Smyth Planning

DA No. 10/0553

86-110 Bellingara Road, Miranda. Residential Aged Care Facility

I write in response to your letter dated 13 July 2010 and our discussion on 19 July 2010. The requests in your letter are taken in turn with a response below.

- View from the northeast corner of RACF in a southwestern direction along Kiama Street;
- View from the northwest corner of RACF in a southeastern direction along the internal road.

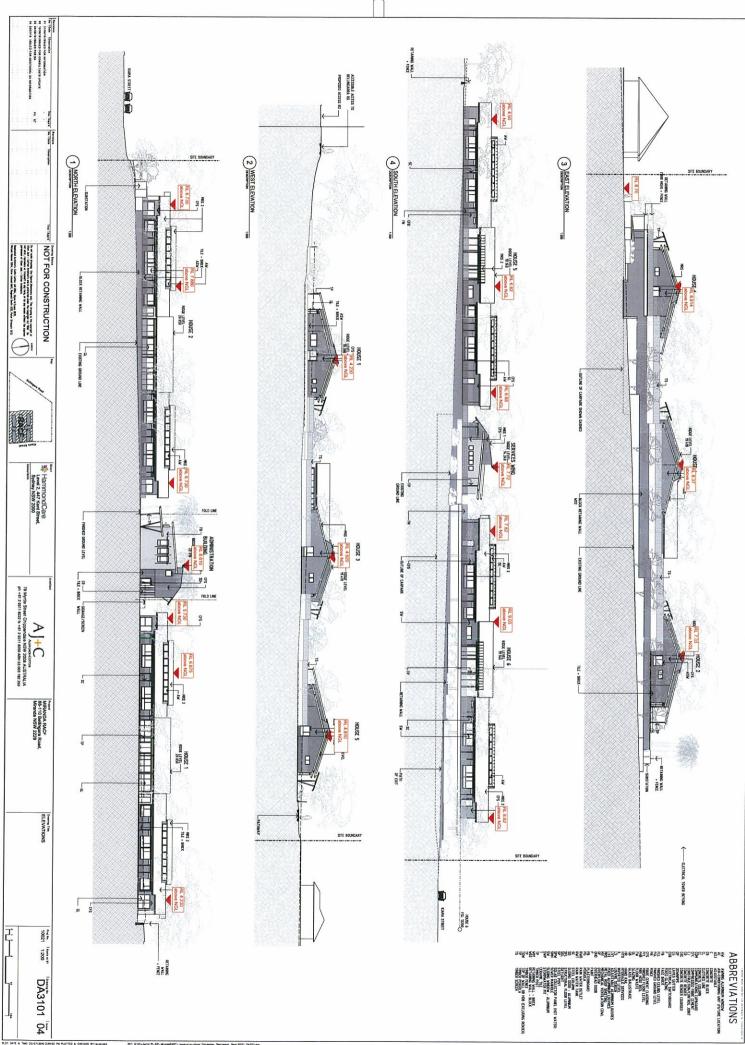
- 4. DA2100 Issue 05 General Basement Arrangement Plan;
- 5. DA2101 Issue 08 General Arrangement Level 01.
- Perspectives showing the proposed building addresses Kiama Street and the internal street to be created between the facility and the independent living units to the west, including detailing of the treatment of the service corridors addressing these streets.

Please find attached the following two perspectives -

ABBREVIATIONS CONTROL THE TO ME REFLANDS AFFECT OF METERS IN 대리클리통토리 "왕완보일박의사학중군도" 몸으로중등도다" 종표 유우고공과당 교리주의 "집다당 닭의 다 맛들이 아 PROFESS TO LINGSCAPE REPORT ANTER LAURAN MENON CALADON ALASAN MENON CALADON CALADON ALASAN MENON CALADON C DA 2100 05

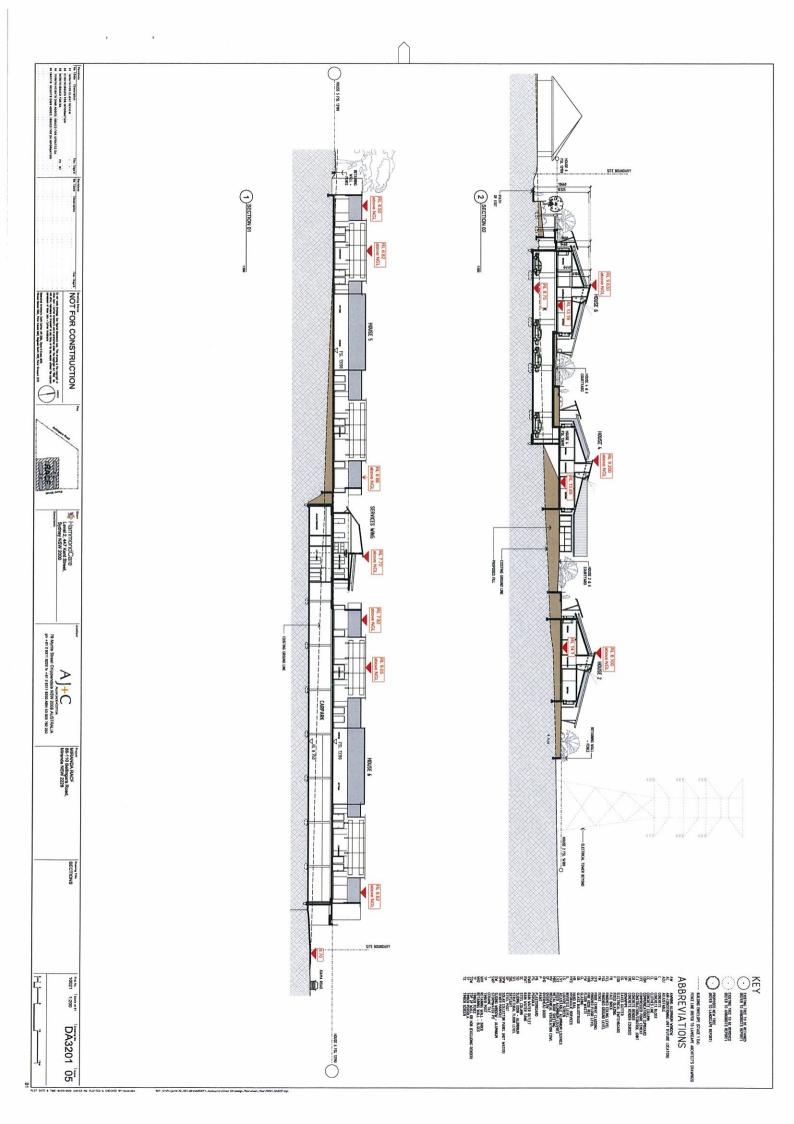
- DA3101 Issue 04 Elevations;
- DA3201 Issue 05 Sections.
- 3. More detailed building setback dimensions for the basement and ground floor levels, particularly with respect to the southern and eastern property boundaries.

Please find attached the following plans with additional setback dimensions to the southern and eastern boundaries (highlighted in red) -
